**Re: 341 Bella Vista Avenue, Review of 9/5/14 Revised Plans relative to Existing Tree Protection**

My last Arborist Report for this project is dated October 28, 2013. For this current report I reviewed the following 9/5/14 plan sheets, which are new to me for this project:

Tree Map (see Notes, page \_).

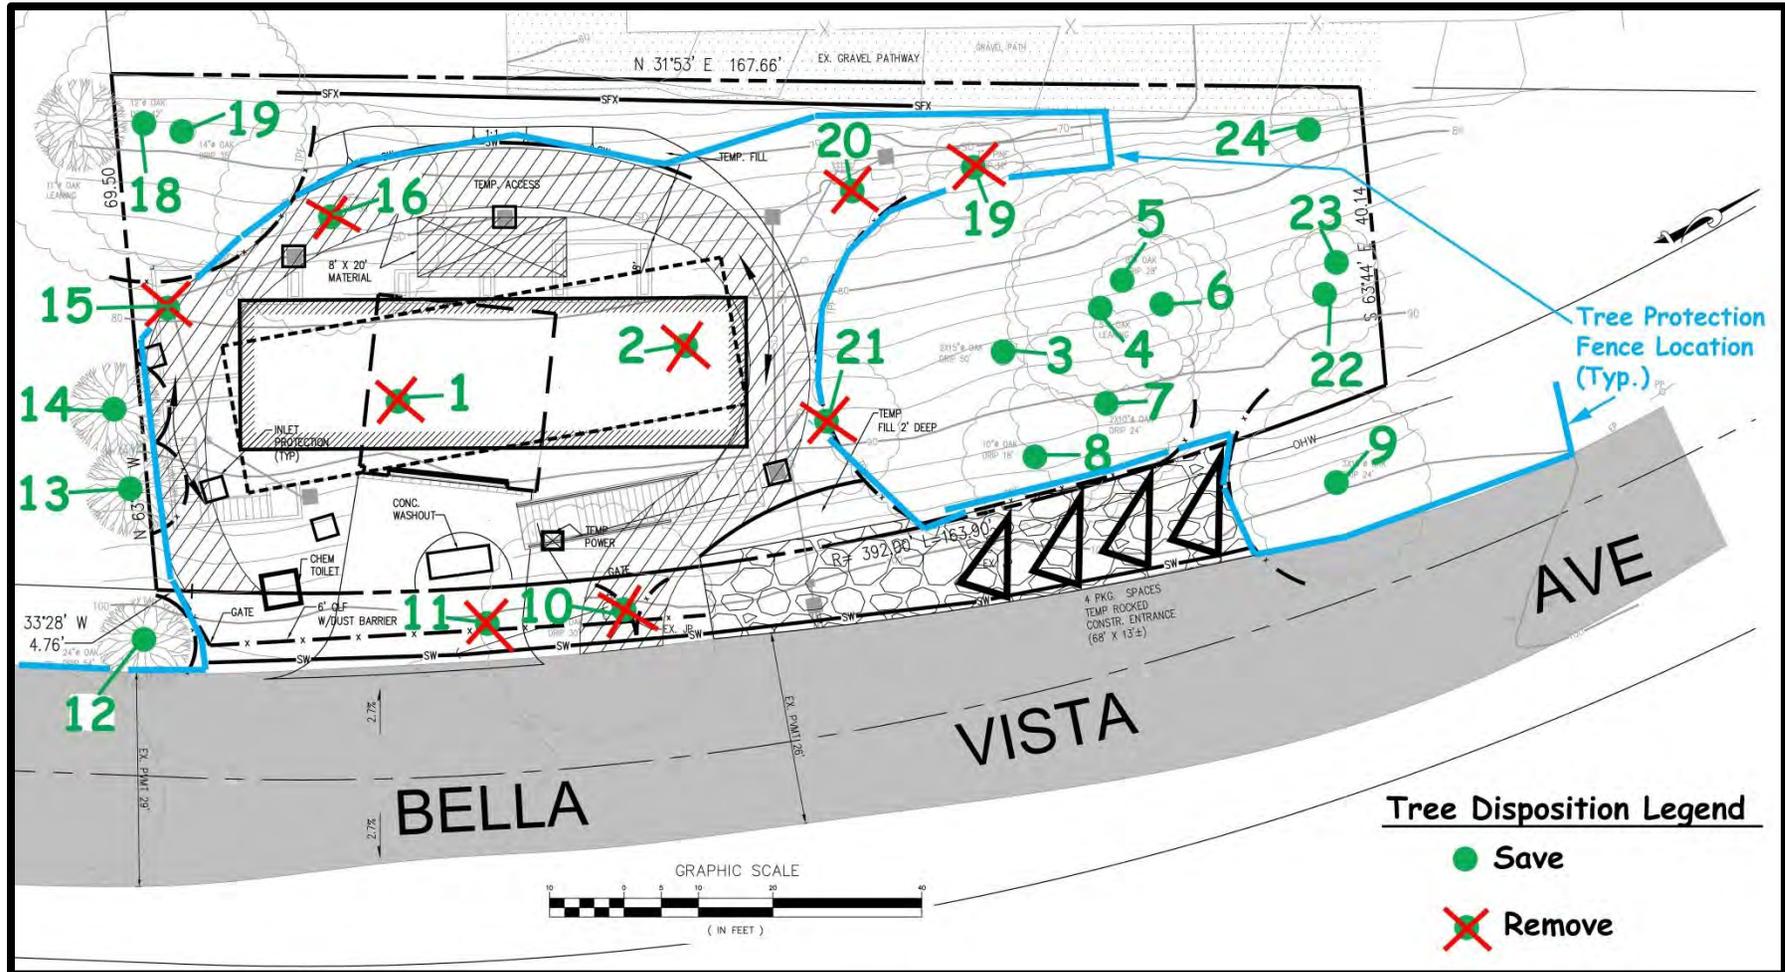
- The following 7 protected trees will be removed: **#1, 2, 10, 11, 15, 19, and 21.**
- The following 3 trees of less than protected size will be removed: **#4, 16 and 20.**
- The following 14 protected trees will be saved and protected: **#3, 5, 6, 7, 8, 9, 12, 14, 14, 17, 18, 22, 23 and 24.**
  - Of the above 14 trees, **#12, 13 and 14** are on neighboring property to the south.

1. The plan sheet used for the Tree Map is the *Site Logistics & Construction Management Plan*, sheet C-3. All of the proposed improvements shown on the 9/5/14 C-Sheets (C1-4) are not shown on this plan, so it may not be obvious why a particular tree is shown to be removed. Read the "Action" and "Notes" column in the Tree Table to find out why a particular tree is listed to be removed.
2. The *Trunk Diameter*, *Size* and *Condition* ratings in the *Tree Table* are from my last evaluation of the trees and the site on October 24, 2013. I did however, ride by the site last week to take a brief look around. The site and the condition of the trees do not seem to have changed appreciably since my October 2013 evaluation.

There are few more trees that will need to be removed than are indicated on the C-3 plans. The reason for this is that not all improvements have been shown on all plans, and a few necessary tree removals were missed because of this. The current tree removal list in this report is a compilation of all improvements on all of the C-3 sheets. Most of the trees that will be removed except for **trees #1, 2 and 10** have been rated as having “Fair” or less preservation suitability, so the majority of trees that will be removed are not good specimens.

4. **Note the revised location for tree protection fencing** on the *Tree Map* in this report.

1. **Remove the following 10 trees: #1, 2,4,10, 11, 15, 16, 19, 20 and 21.**
2. **Save and protect the following 14 trees: #3, 5, 6, 7, 8, 9, 12, 13, 14, 17, 18, 22, 23 and 24.**
